Access Compliance Report

Public Rights-of-Way

(Curb Ramps)

Intersection ID: 12618	Main Street: E_5TH_ST	Cross Street: N_CALDWELL_ST	Location: NE
ADA ID: A29702C2F951	Ramp Type: BlendTrans2	Initial Pass/Fail: Pass	Overall Compliance: No
			Severity Score: 37.75

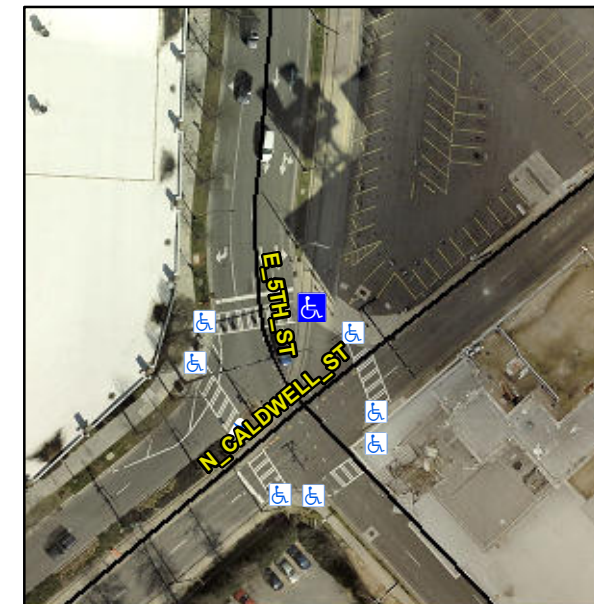
R304.5.3, R305.1.4, R302.7.2, R302.3, R402.2

Compliance	Description	Data	Compliance	Description	Data
N/A	Ramp Length (in)	82.0	Yes	BlendTrans Slope (%)	2.4
Yes	Ramp Width (in)	80.0	No	BlendTrans XSlope (%)	2.4
N/A	Flare Type LT	Sloped	N/A	Flare Type RT	Sloped
Yes	Flare Slope LT (%)	2.7	Yes	Flare Slope RT (%)	4.9
N/A	Flare Traversable LT?	Yes	N/A	Flare Traversable RT?	Yes
N/A	Landing Length (in)	N/A	Yes	DWS Provided?	Yes
N/A	Landing Width (in)	N/A	Yes	DWS Contrast?	Yes
N/A	Landing Slope (%)	N/A	Yes	DWS Length (in)	25.0
N/A	Landing X Slope (%)	N/A	No	DWS Full Width?	No
N/A	Landing Curb? (Y/N)	No	Yes	DWS Offset (in)	0.0
N/A	Shared Landing?	No			
Yes	Gutter Ponding?	No	Yes	Gutter Slope (%)	0.4
No	Gutter Lip Ht (in)	1.0	Yes	Gutter X Slope (%)	1.2
N/A	Painted X Walk1?	Yes	N/A	Painted X Walk2?	N/A
	X Walk 1 Direction	To NW		X Walk 2 Direction	N/A
	X Walk 1 Width (in)	121.0		X Walk 2 Width (in)	N/A
	X Walk 1 Slope (%)	4.6		X Walk 2 Slope (%)	N/A
	X Walk 1 X Slope (%)	0.7		X Walk 2 X Slope (%)	N/A

Yes	Ramp inside XWalk1?	Yes	N/A	Ramp inside XWalk2?	N/A
	Road Slope (%)	0.7		Clear Space?	Yes
	Road X Slope (%)	4.6	N/A	Clear Space to XWalk (in)	N/A
No	Any Obstructions?	Yes	Yes	Storm Grate/Utility Hazard?	No
	Obstruction Type			Storm Grate/Utility Type	
				CDOT VAULT 0.5	N/A
			Yes	Surface Condition? (G/P)	Good
			N/A	Curb Slope (%)	0.6

Remove & Replace Curb Ramp With Two New Directional Ramps or Equivalent. Grind Gutter Lip. Relocate Obstruction.
